Planning Commission Meeting Packet

June 10, 2014

CITY OF SHERWOOD
Staff Report
Cedar Brook Planned Unit Development
PUD 14-01 and SUB 14-01

STANDARD DRAWING TITLE		DRAWING NUMBER
STANDARD LOCAL STREET EYEBROW		RD-12
Any alteration of this drawing may not be associated in any way with the City of Sherwood Standard Drawings.	SCALE	DATE
	N.T.S.	JUN' 13

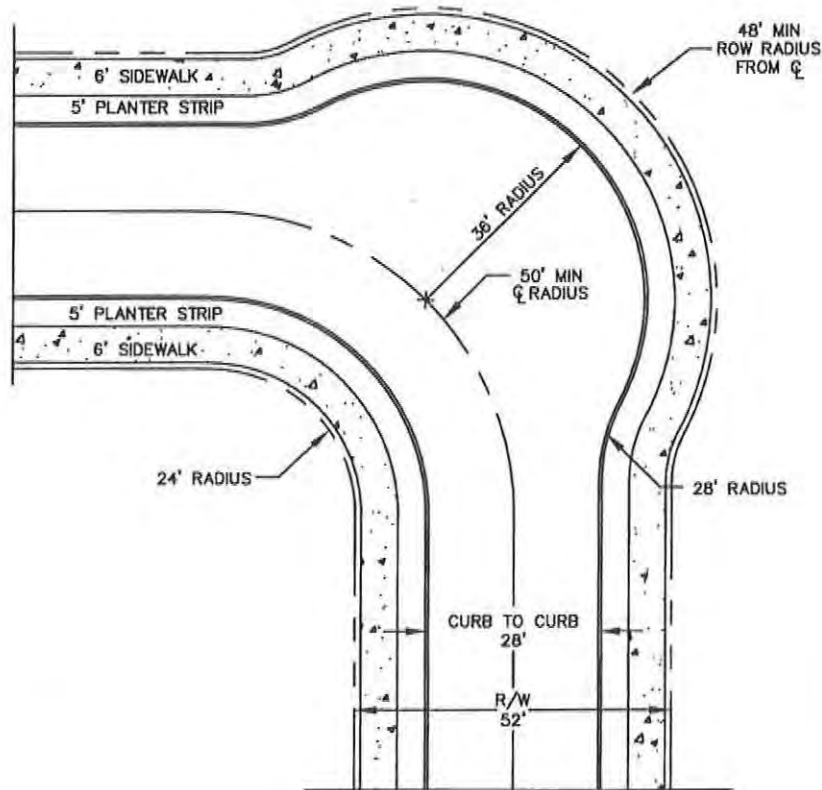
The developer has proposed a bulb out within the private street that will meet emergency access in place of the standard city bulb out (detail RD-12). Since this is a PUD with higher density the standard bulb out would make it considerably difficult to obtain densities since it is beyond the width of the standard right-of-way. The standard bulb out is meant more for standard single family home subdivisions in corner areas of the property to obtain access to the corner. The bulb out proposed appears to give adequate width for a vehicle to pull over for an emergency vehicle. Since the standard bulb out is impractical for use in this situation, I recommend acceptance of the request with the following conditions:
